Access Compliance Report

Public Rights-of-Way

(Curb Ramps)

Intersection ID: 53165	Main Street: DIXIE_RIVER_RD	Cross Street: N/A	Location: SE
ADA ID: BA5CE36B5EA5	Ramp Type: Perp	Initial Pass/Fail: Fail	Overall Compliance: No
Severity Score: 21.25			
Codes/Mitigation Info/Possible Solution		Field Measurements/Component Compliance

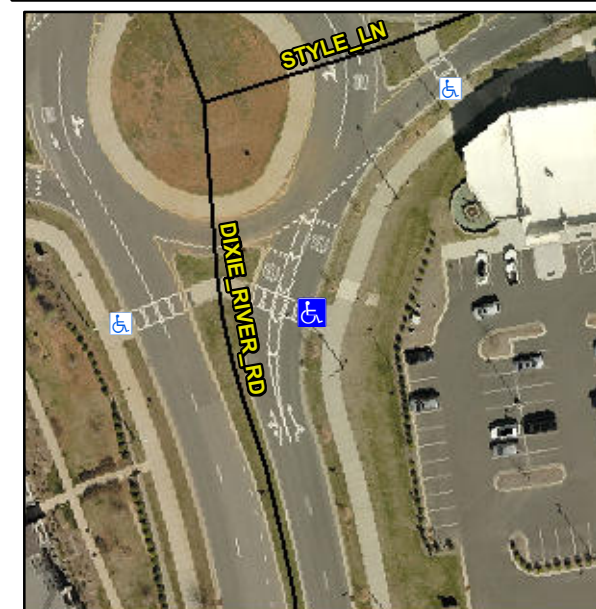
Not Found, R304.5.1, R304.5.3

Compliance	Description	Data	Compliance	Description	Data
N/A	Ramp Length (in)	96.0	Yes	Ramp Slope (%)	6.4
No	Ramp Width (in)	47.0	No	Ramp XSlope (%)	6.4
N/A	Flare Type LT	N/A	N/A	Flare Type RT	N/A
N/A	Flare Slope LT (%)	N/A	N/A	Flare Slope RT (%)	N/A
N/A	Flare Traversable LT?	N/A	N/A	Flare Traversable RT?	N/A
N/A	Landing Length (in)	N/A	N/A	DWS Provided?	N/A
N/A	Landing Width (in)	N/A	N/A	DWS Contrast?	N/A
N/A	Landing Slope (%)	N/A	N/A	DWS Length (in)	N/A
N/A	Landing X Slope (%)	N/A	N/A	DWS Full Width?	N/A
N/A	Landing Curb? (Y/N)	N/A	N/A	DWS Offset (in)	N/A
N/A	Shared Landing?	N/A			
N/A	Gutter Ponding?	N/A	N/A	Gutter Slope (%)	N/A
N/A	Gutter Lip Ht (in)	N/A	N/A	Gutter X Slope (%)	N/A
N/A	Painted X Walk1?	Yes	N/A	Painted X Walk2?	N/A
	X Walk 1 Direction	To NW		X Walk 2 Direction	N/A
N/A	X Walk 1 Width (in)	111.0	N/A	X Walk 2 Width (in)	N/A
	X Walk 1 Slope (%)	5.6		X Walk 2 Slope (%)	N/A
	X Walk 1 X Slope (%)	5.6		X Walk 2 X Slope (%)	N/A

Remove & Replace Entire Ramp.
